ADDENDUM NUMBER 1

DATE: 12/20/2024

PROJECT: SEMCO Emergency Operations Center

ARCHITECT/ENGINEER: Anderson, Eckstein & Westrick, Inc.

A101

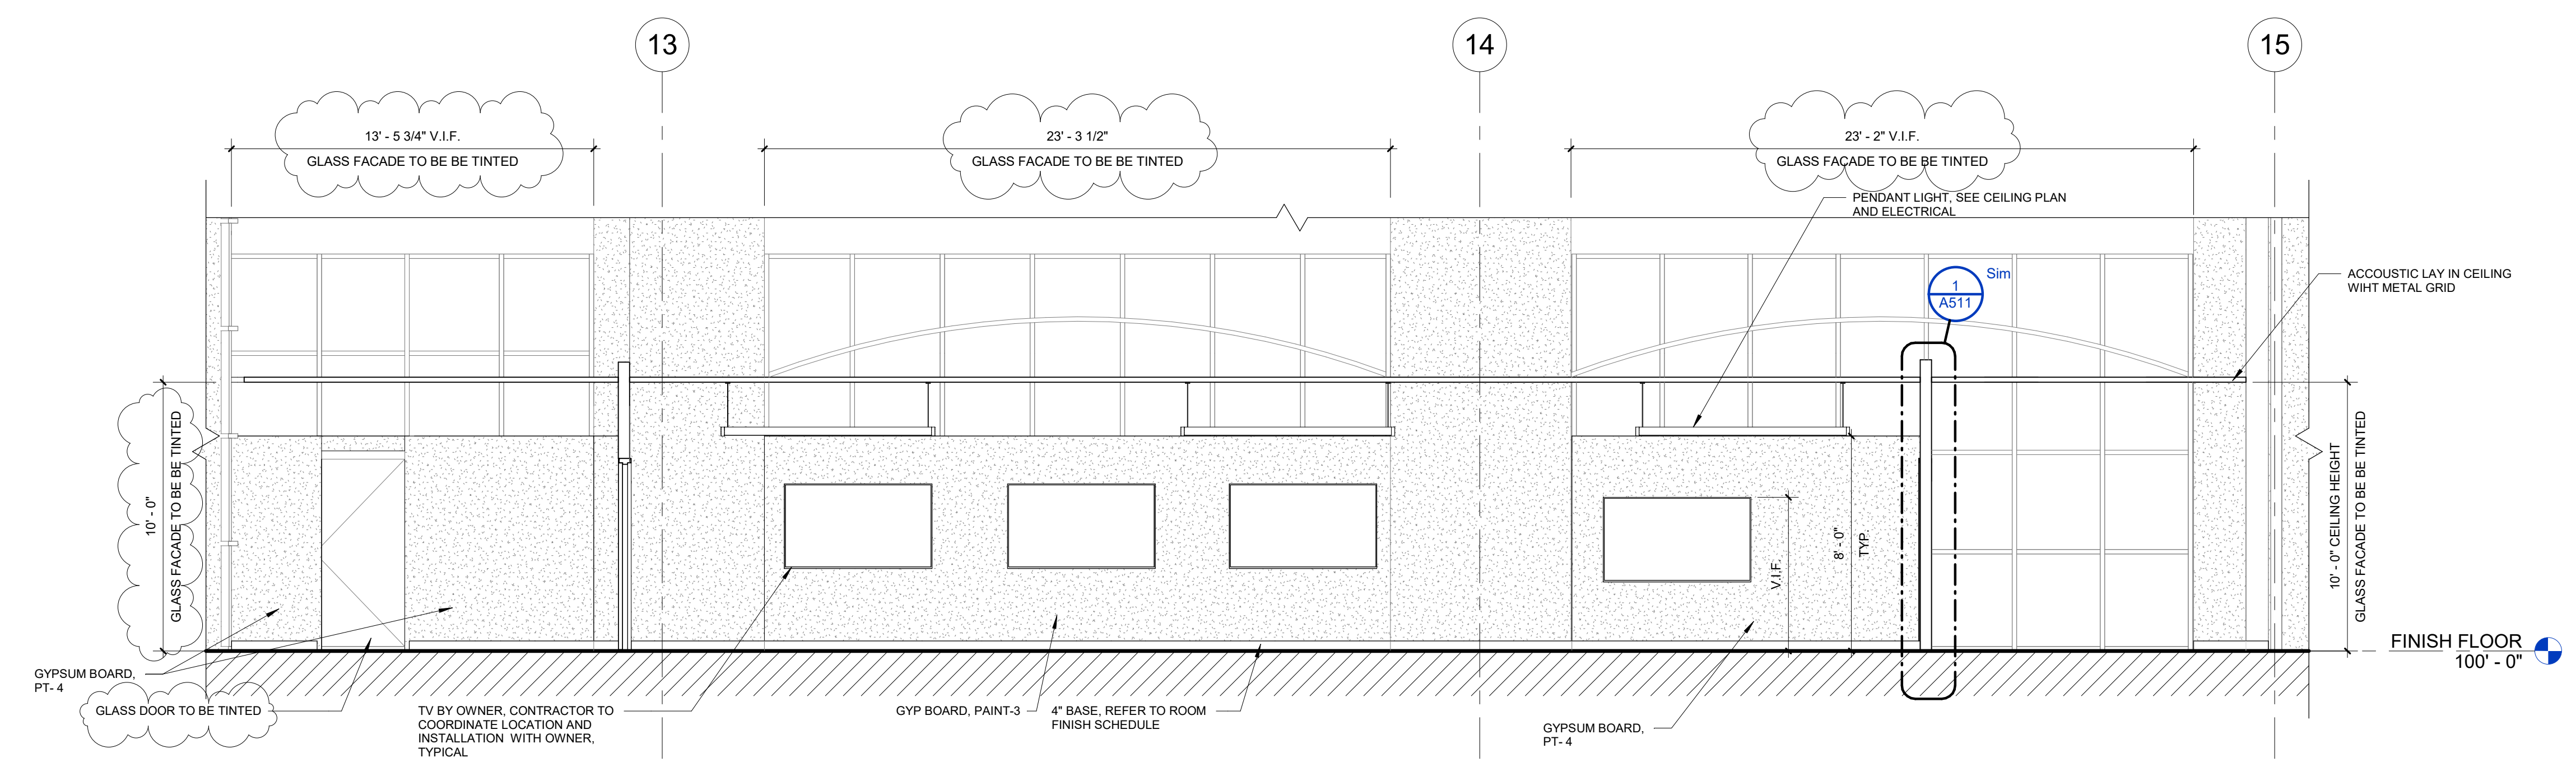
12. **Q:** Per page E101, please clarify fire devices for rooms 102/3/4/5, 107 and 111.
A: Refer to sheet E101 for revised fire devices needed.
13. **Q:** Per page A101, please clarify wall types for rooms 103/4/5, 108,109 and 111
A: All walls not labeled are wall type A, refer to partition type legend.

14. **Q:** Per page A101, please further clarify wall type A1
A: Wall type A1 should follow UL listed 2 Hour Rated U301.

1. SHEET A101: reissued
 - a. Partition moved 2" off existing curtain wall
 - b. Added UL Listing U301 for partition type A1
 - c. Added Gas Supervisor Office Callout 11/A511
 - d. Added Fatigue Room Call out 10/A511
2. SHEET A301: reissued
 - a. Partition moved 2" off existing curtain wall
 - b. Detail 2 added dimensions for window tint
3. SHEET A412: reissued
 - a. Toilet 109 revised to Toilet 107
 - b. Toilet 117 revised to Toilet 114
4. SHEET A511: reissued
 - a. Detail 3 partition moved 2" off existing curtain wall
 - b. Detail 4 partition moved 2" off existing curtain wall
 - c. Detail 10 added
 - d. Detail 11 added
5. SHEET A611: reissued
 - a. Revised Toilet room wall finishes

2 BUILDING SECTION
 A301 1/4" = 1'-0"

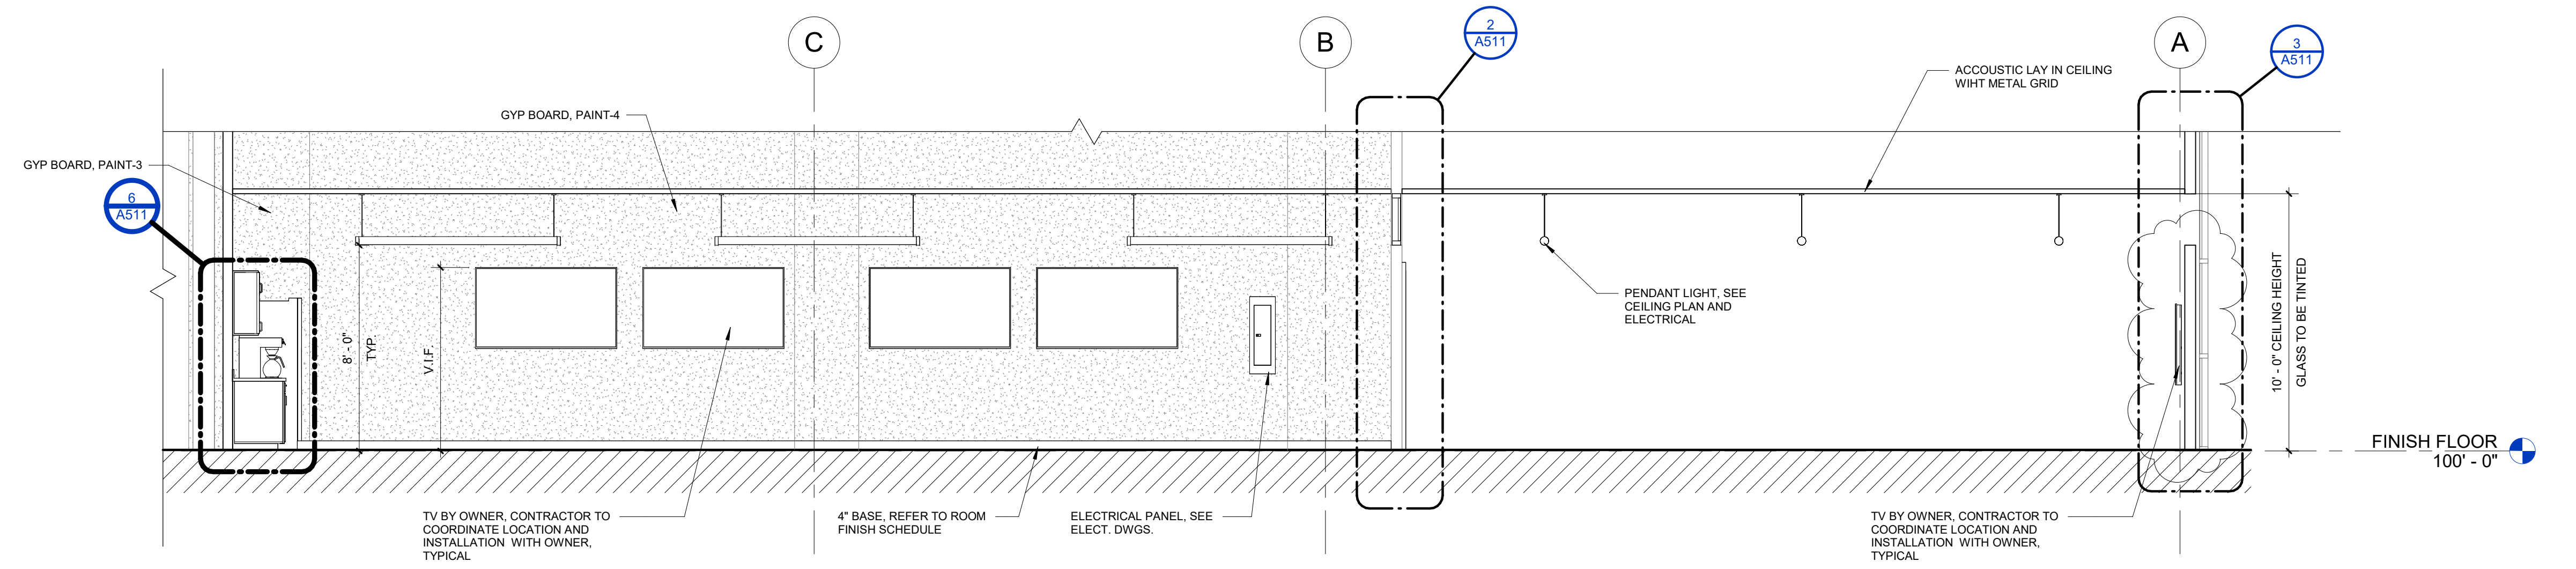
5. **Q:** No elevation for windows that require window tinting. Please provide size, and/or elevation.
A: Refer to Detail 2/A301 Building Section added dimensions to shows extent of windows that will require tinting. Tinting should extend from height of new ceiling (10'-0") to floor on all curtain walls on exterior of building.
